Subject: **1299 1st Avenue, New York, NY**
NYSDEC BCP No. C231072
Addendum to the Remedial Investigation Work Plan

Integral Engineering P.C. (Integral) has prepared this Addendum to the Remedial Investigation Work Plan (RIWP), dated November 2013, on behalf of 3SK Corporation (3SK) (Participant), for the property located at 1299 1st Avenue (Block 1444, Lot 30), New York, NY (Site). The Site is currently enrolled in the New York State Brownfield Cleanup Program (BCP) and listed as Site No. C231072.

Figure 5.
Proposed Offsite Soil Vapor Locations
Addendum to the RIWP
1299 1st Avenue
New York, New York

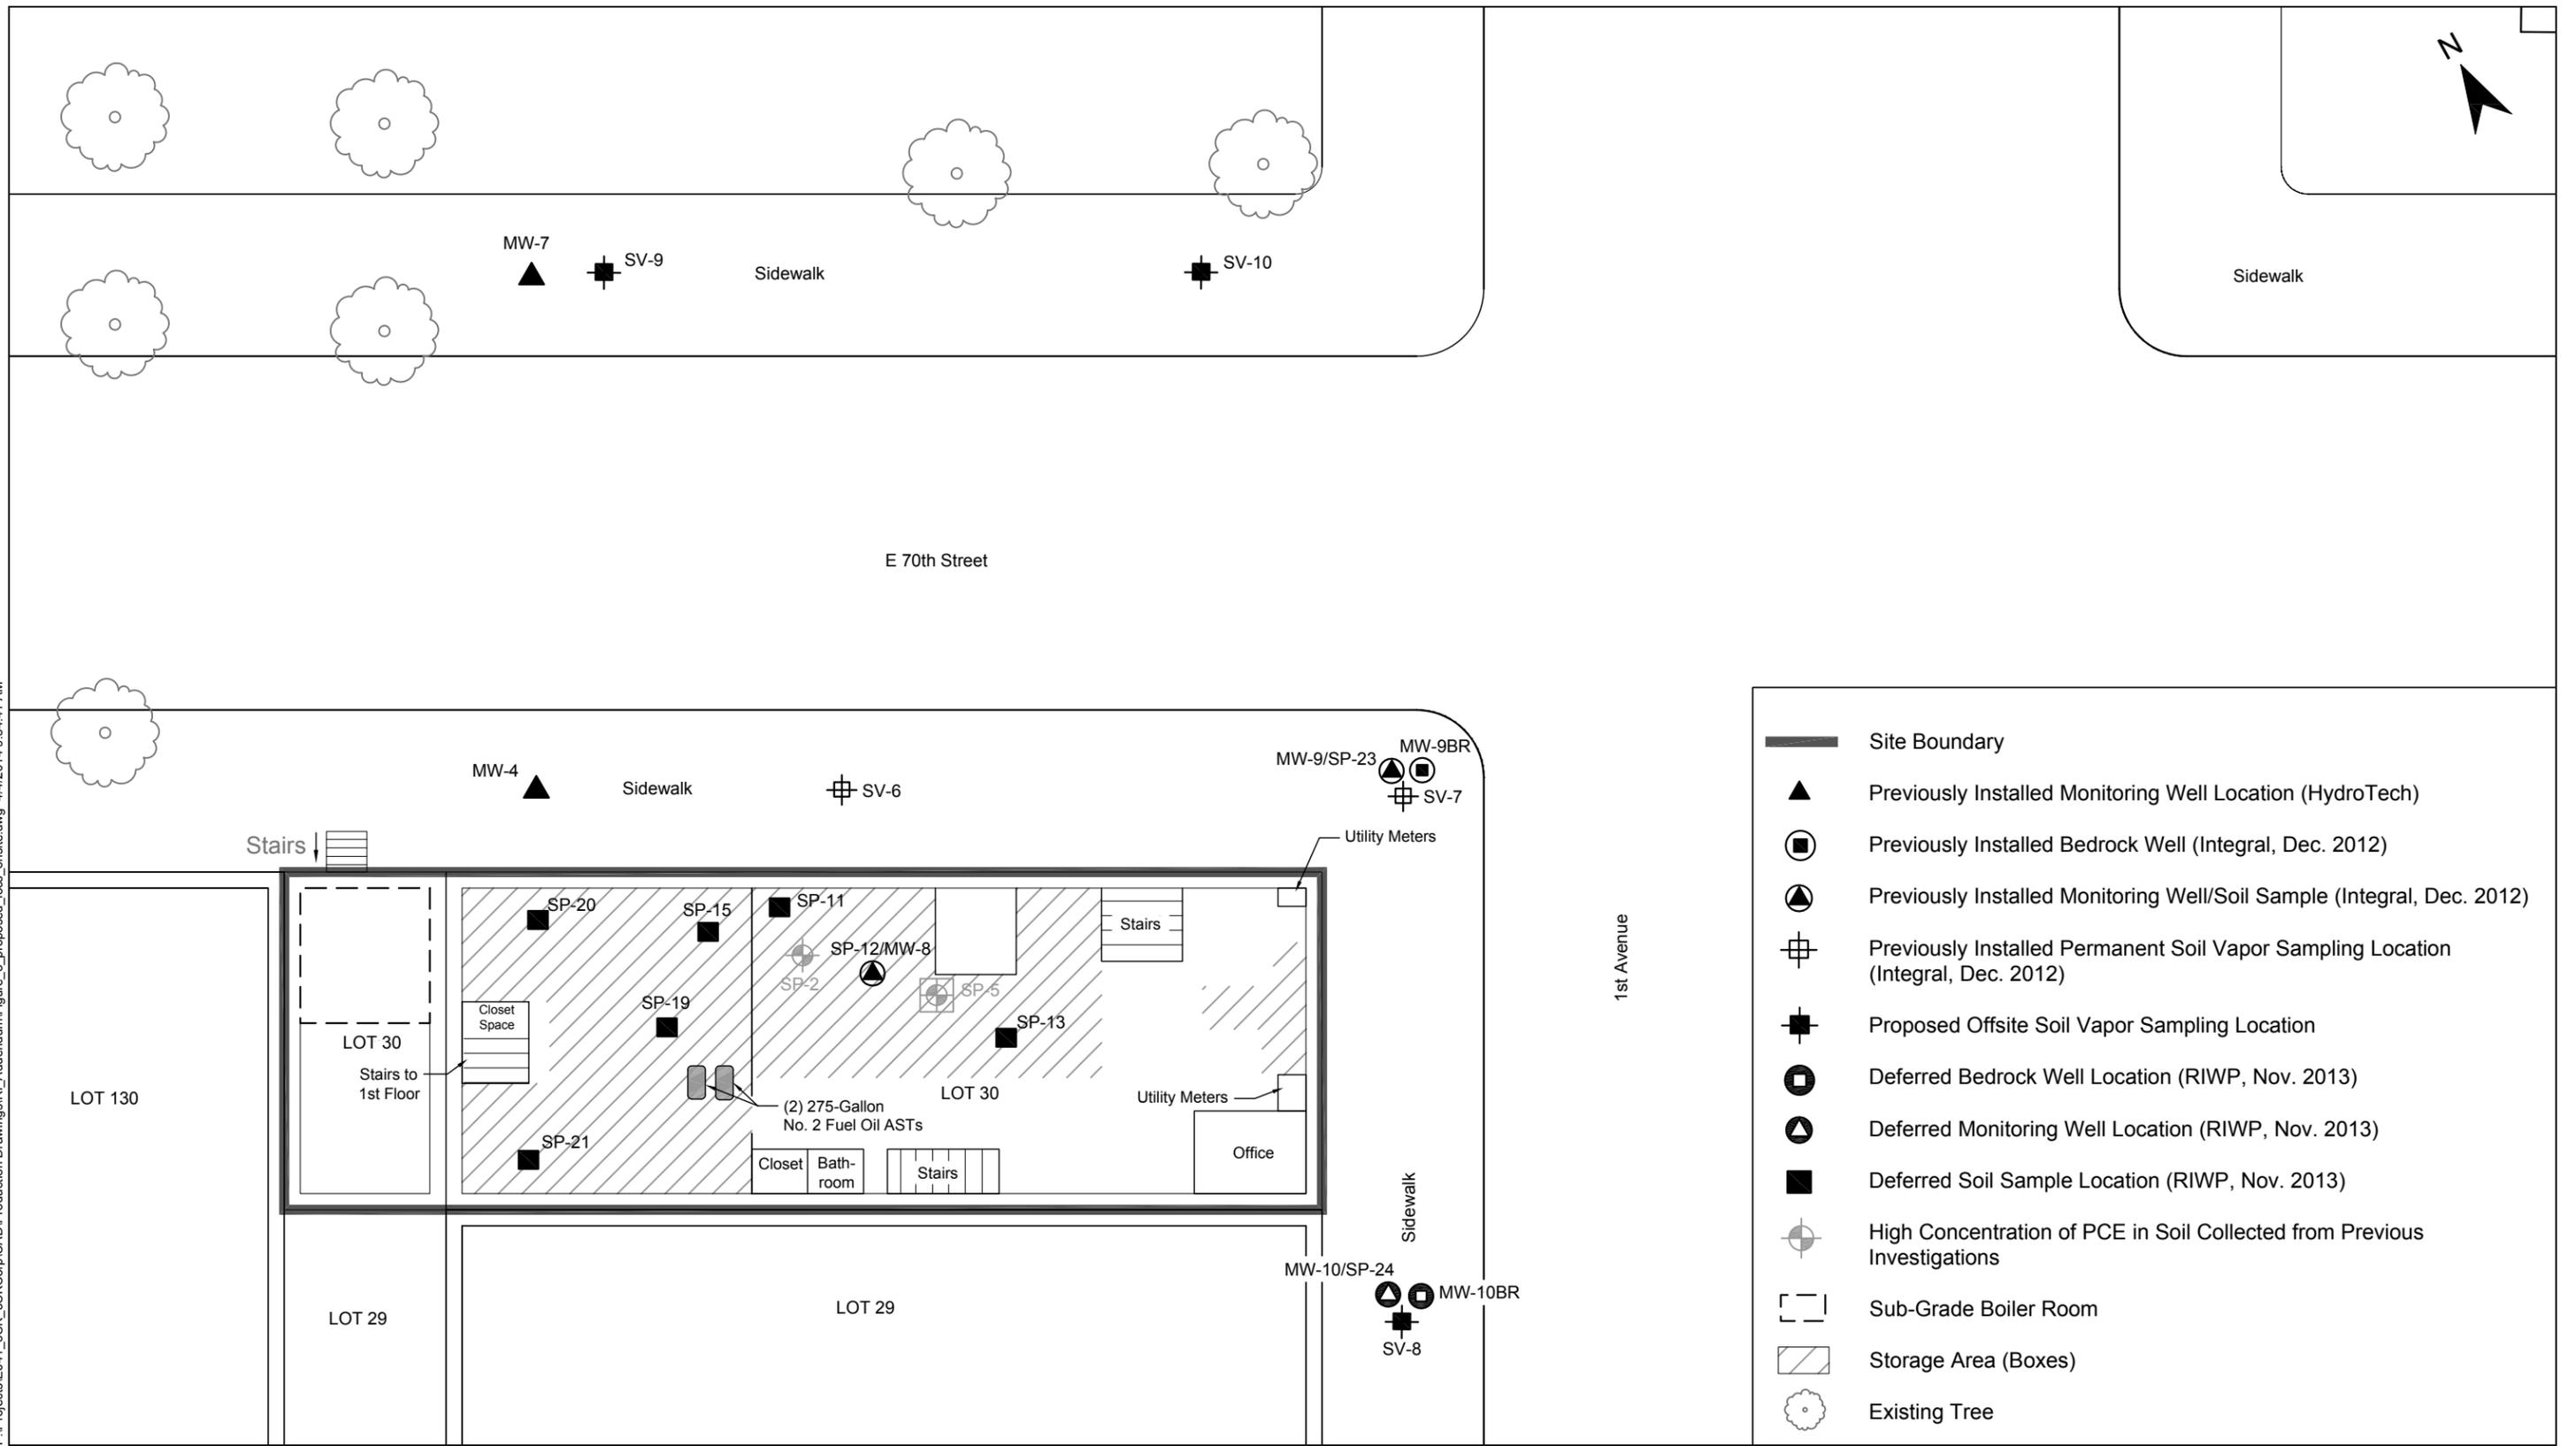
In order to evaluate the potential for impacted soil vapor to migrate offsite to the north, two permanent soil vapor points (SV-9 and SV-10) will be installed along the northern sidewalk of 70th Street. Soil vapor points will be installed to the depth of the Site basement (approximately 6.5 ft-below sidewalk grade) using a hand held hammer drill. Methodology for installation and sampling of SV-9 and SV-10 will be identical to the installation and sampling methodology detailed above for previously approved soil vapor point (SV-8).

Proposed offsite soil vapor sample locations are provided on Figure 5.

- Installation of monitoring well MW-10 and bedrock well MW-10BR;
- Sampling of monitoring wells MW-1, MW-2, and MW-6A; and
- Installation and sampling of soil borings SP-13, SP-14, SP-15, SP-19, SP-20, SP-21, and SP-24.

Deferred scope items are visible on Figure 5.
